WATERVUE

643-651 HUNTER STREET NEWCASTLE NSW 2300

DEVELOPMENT APPLICATION SHEET LIST		
DRAWING NO.	TITLE	REVISION
DA000	PLAN - LOCATION & DRAWING SCHEDULE	F
DA002	SITE ANALYSIS	B
DA003	PREDICT LOCATION PLAN	C
DA005	SITE PLAN	B
DA006	SHADOW DIAGRAMS	B
DA007	SHADOW DIAGRAMS	B
DA008	SHADOW DIAGRAMS	A
DA009	SOLAR ACCESS DIAGRAM	B
DA010	VENTILATION DIAGRAMS	B
DA011	PLANNING - GFA	C
DA012	UNIT AREA FOR CARPARKING GEN.	B
DA101	GROUND FLOOR	E
DA102	PARKING LEVEL 1	D
DA103	PARKING LEVEL 2	C
DA104	PARKING LEVEL 3	C
DA105	PLAN - PODIUM	E
DA106	PLAN - TYPICAL LOWER	D
DA107	PLAN - TYPICAL UPPER	C
DA111	PLAN - PENTHOUSES	B
DA112	ROOF	B
DA200	STREETSCAPE ELEVATIONS	B
DA201	ELEVATIONS - NORTH AND EAST	F
DA202	ELEVATIONS - SOUTH AND WEST	C
DA301	SECTIONS	C
DA321	RAMP SECTION CARPARK	C
DA401	PERSPECTIVE	B
DA402	PERSPECTIVE	B
DA403	PERSPECTIVE	B
DA409	MATERIALS + FINISHES	B
DA801	PODIUM LEVEL PRIVACY SCREENS	A
DA802	SIGNAGE DESIGN INTENT	A

DRAWING No. DA106

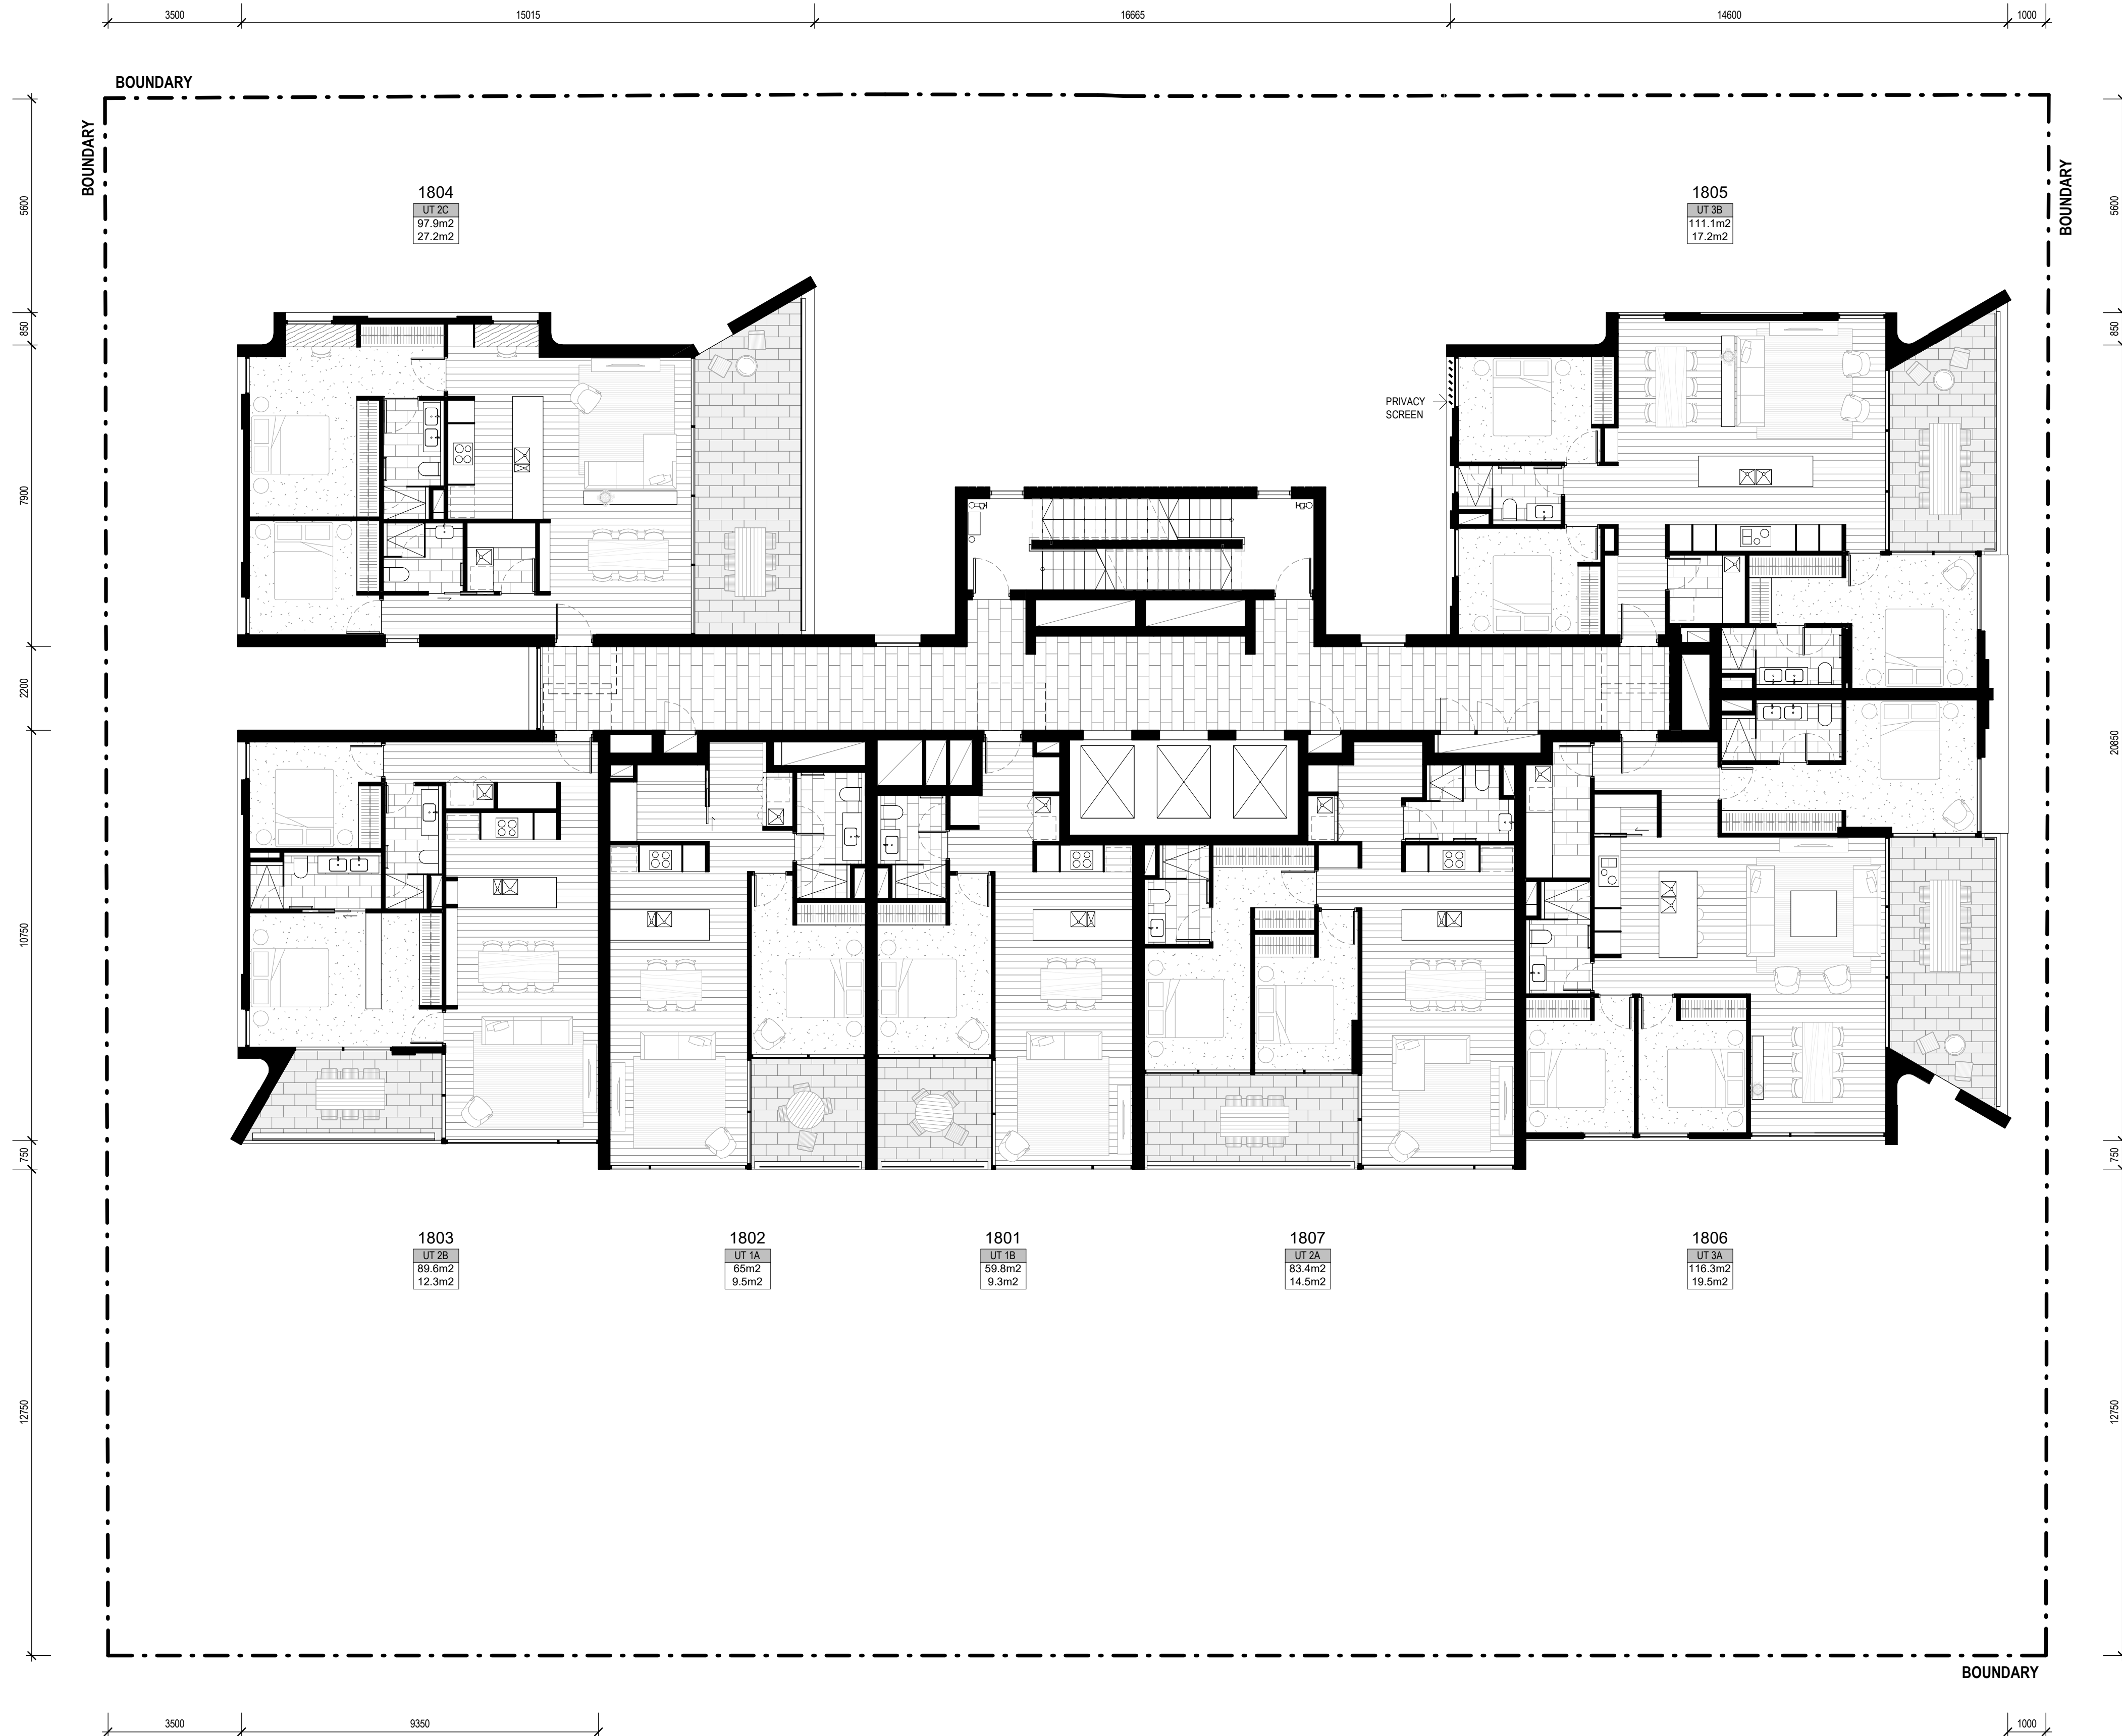
DA RFIs - 27.03.2023
24m BUILDING SEPARATION LINE ABOVE 45m INDICATED
PRIVACY SCREEN LOCATION CLARIFIED

DRAWING No. **DA107**
DRAWING TITLE **PLAN - TYPICAL UPPER**
SCALE **1 : 100 @ A1**
DATE **2023**

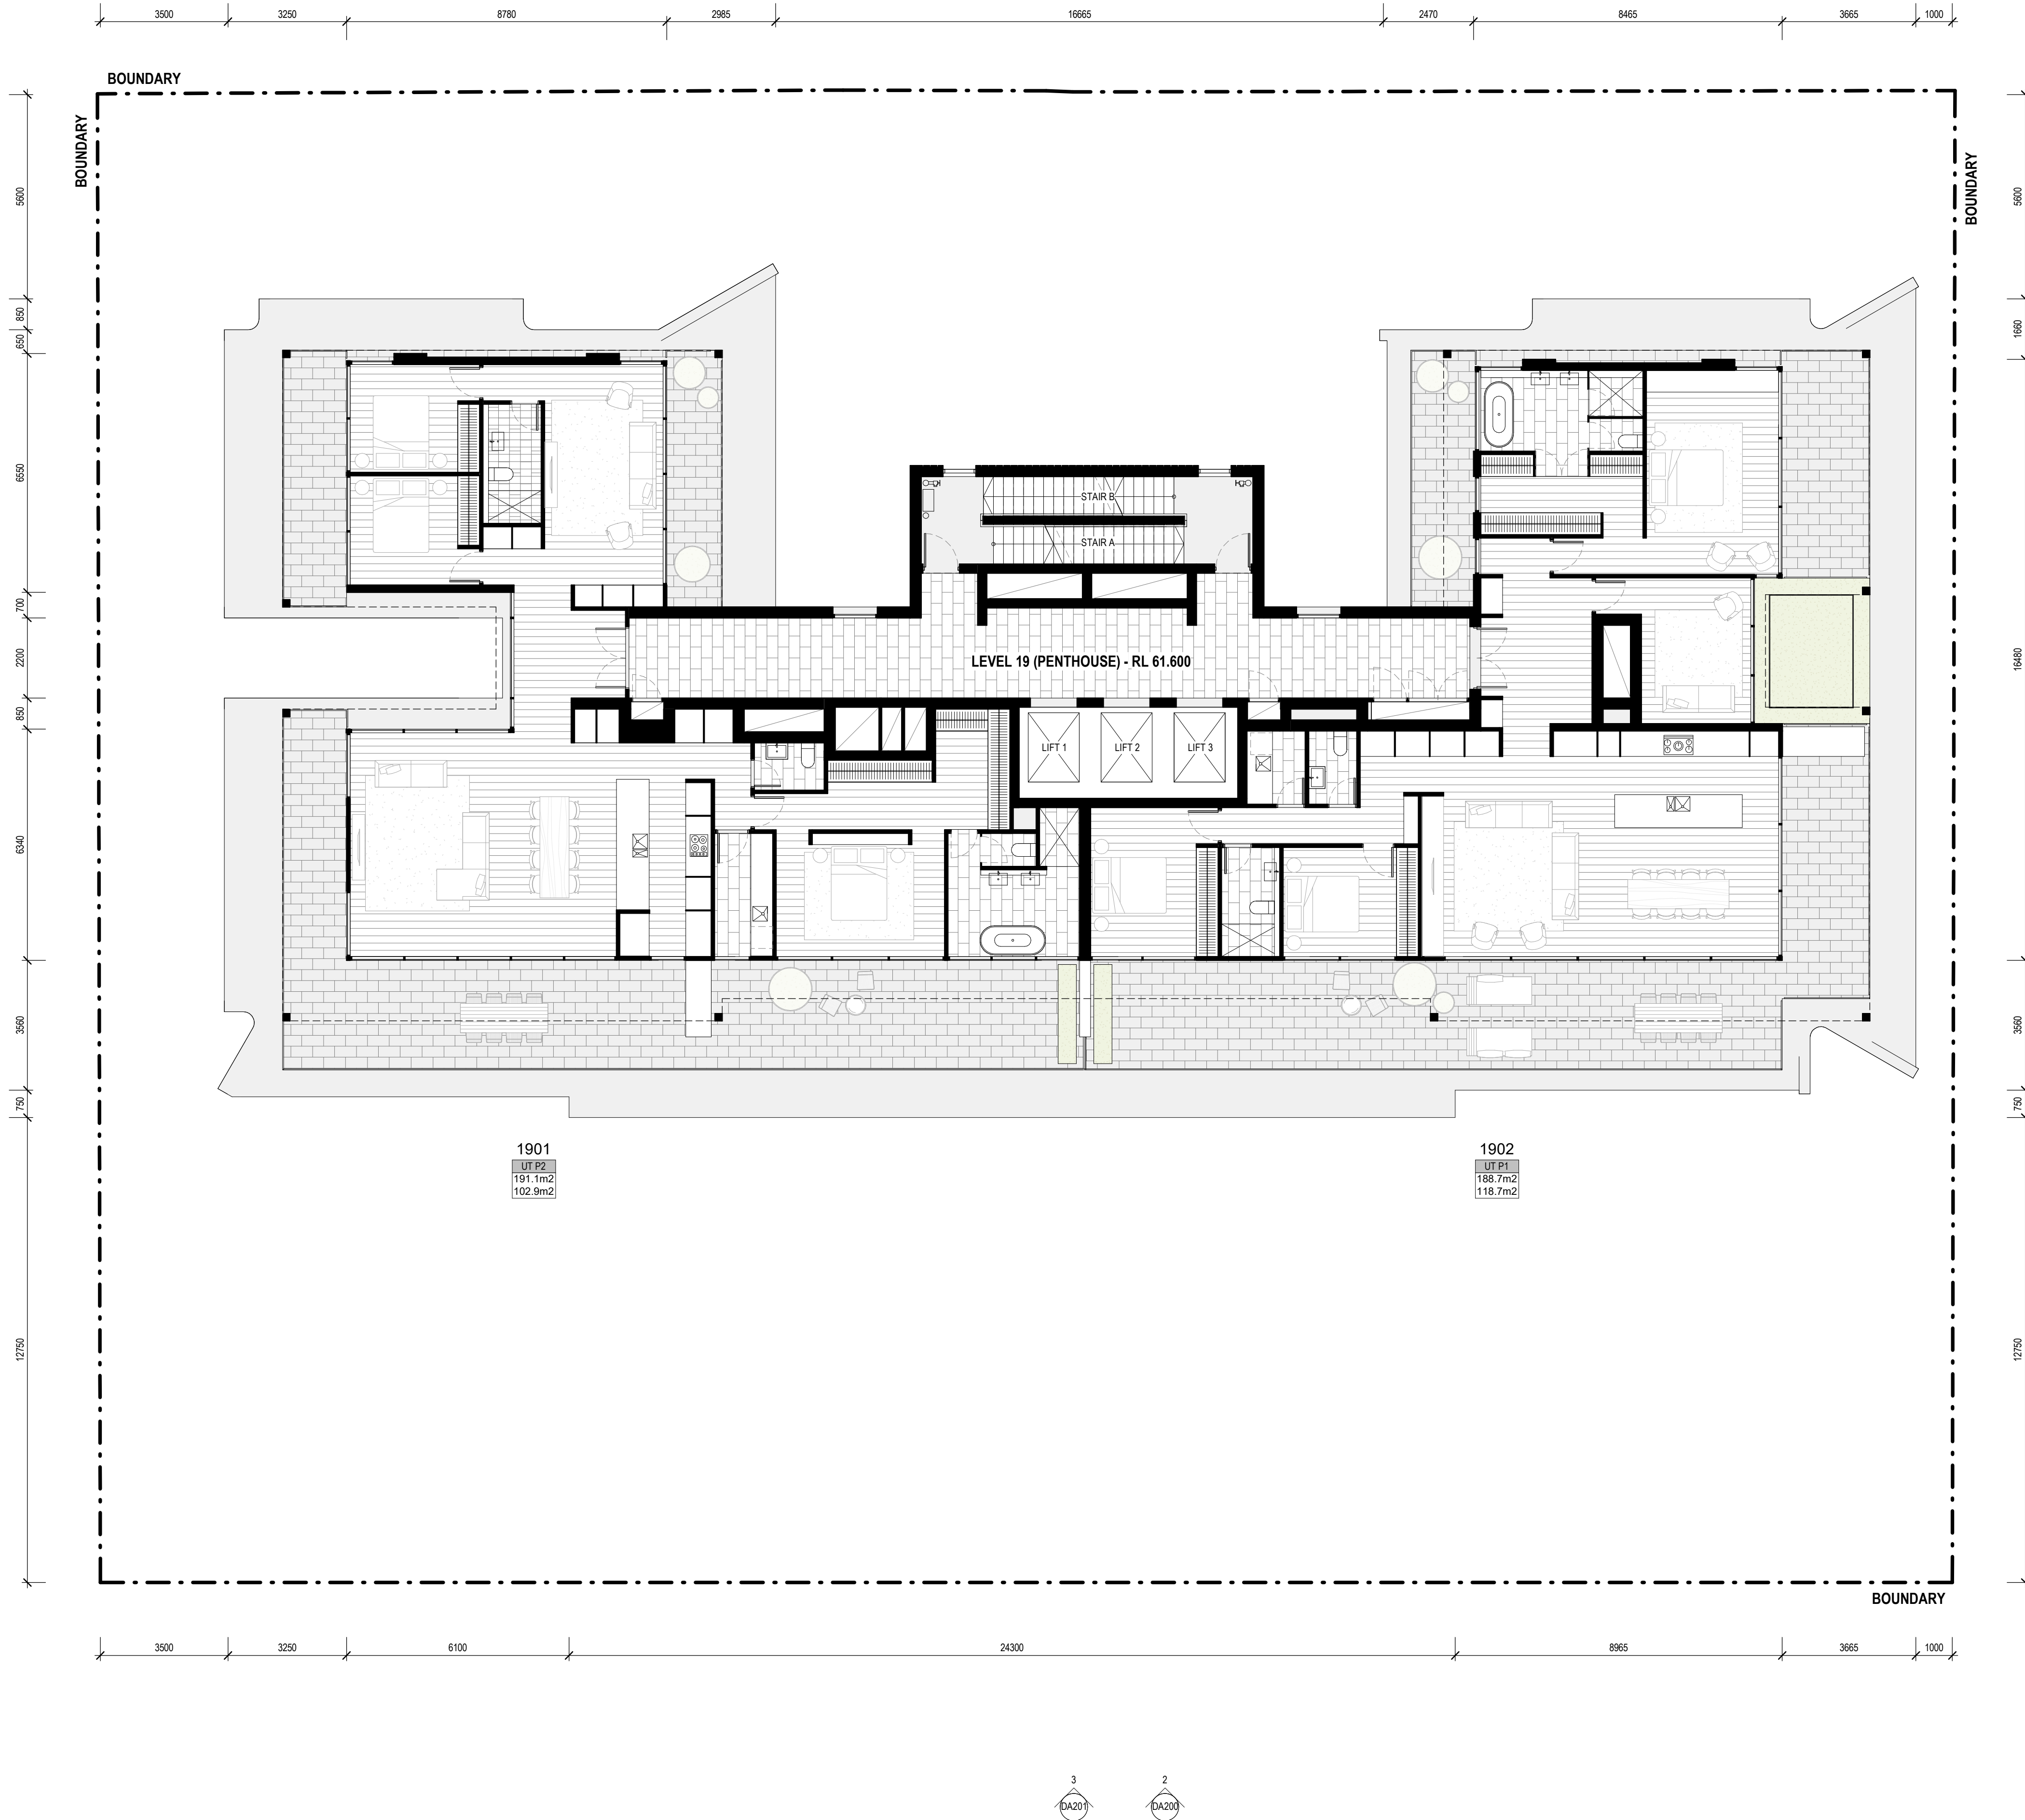
DA RFIs - 27.03.2023
24m BUILDING SEPARATION LINE ABOVE 45m INDICATED
PRIVACY SCREEN LOCATION CLARIFIED
